DEPARTMENT OF NATURAL RESOURCES
DIVISION OF OIL, GAS AND MINING

April 18, 1991

RE: Proposed Spillway Modification, NOV Abatement Plan, N91-39-1-4: 1 of 4, (received March 22, 1991),
Proposed Small Area Exemption, NOV Abatement Plan, N91-39-1-4: 4 of 4, Hiawatha Mines, U.S. Fuel Co., ACT/007/011, Folder #2, Carbon County, Utah

STAGE VOLUME CURVE

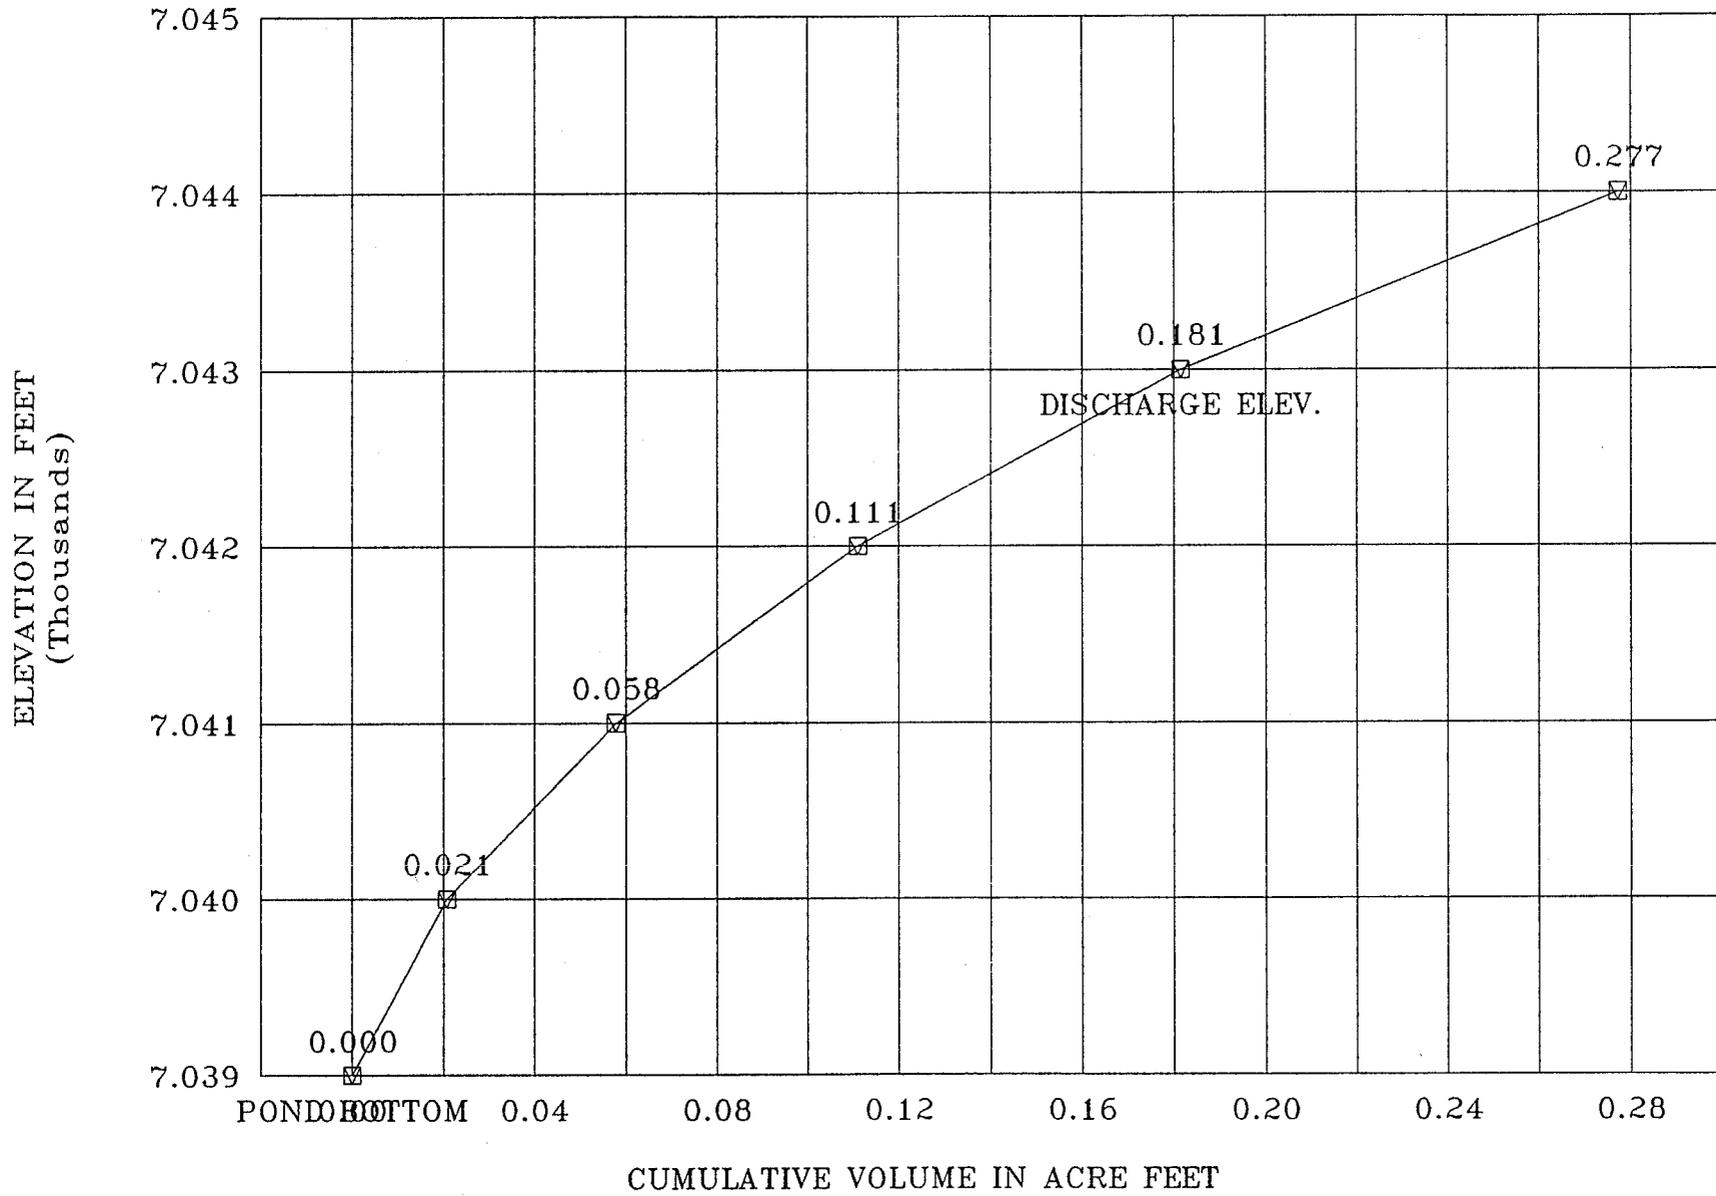
The Division has verified the applicant's drainage area, predicted runoff volume, and the stage-volume capacity of the proposed catch basin. The applicant's calculations are acceptable.
